TMI-16-091
September 8, 2016

Three Mile Island Nuclear Station, Unit 1
Renewed Facility Operating License No. DPR-50
NRC Docket No. 50-289

Subject: Response to Draft Request for Additional Information Regarding the Submittal of Relief Request RR-16-01 Concerning the Use of ASME Code Case N-722-2 for Three Mile Island Nuclear Station, Unit 1

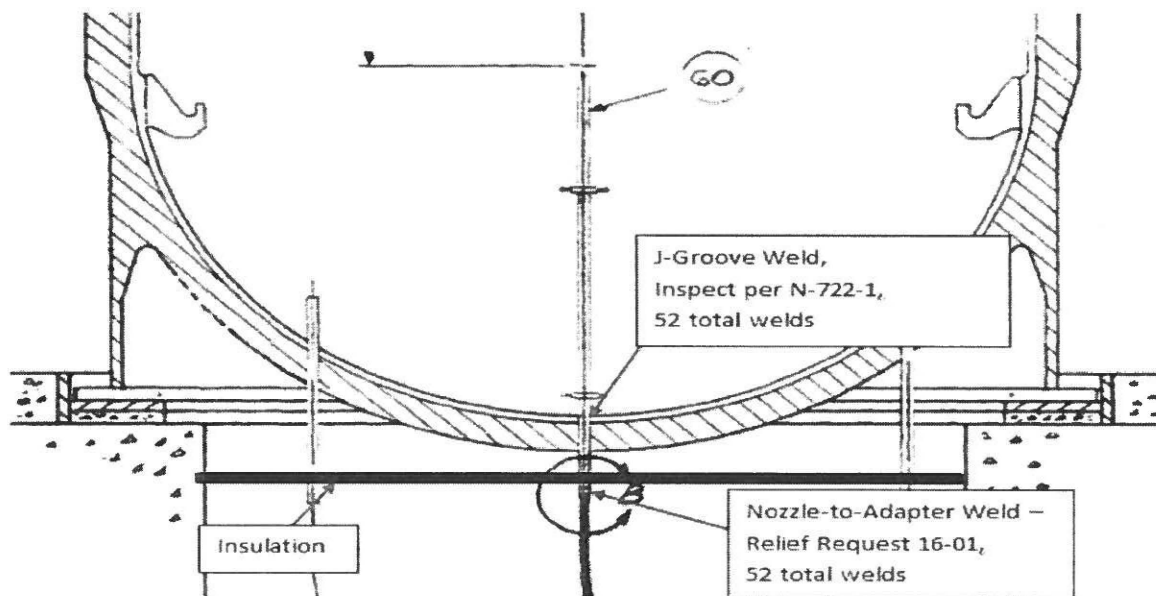
Table 1 of the relief request identifies weld number RCT0001INCORENOZZLES and number "52" as reactor vessel lower head incore penetrations. Discuss the total number of nozzle-to-adapter weld(s) that are covered under the relief request.

The number "52" in Table 1 represents the population of Incore Monitor Instrument penetration assemblies (incore penetrations). Each penetration includes the one (1) J-Groove Weld and the one (1) Nozzle-to-Adapter Weld. The Relief Request RR-16-01 covers the 52 Nozzle-to-Adapter welds. The identifier RCT00001INCORENOZZLES represents the 52 penetrations with 2 welds in each penetration. Therefore, the single identifier number applies to 104 welds. All 52 of the Nozzle-to-Adapter welds are covered under this relief request.
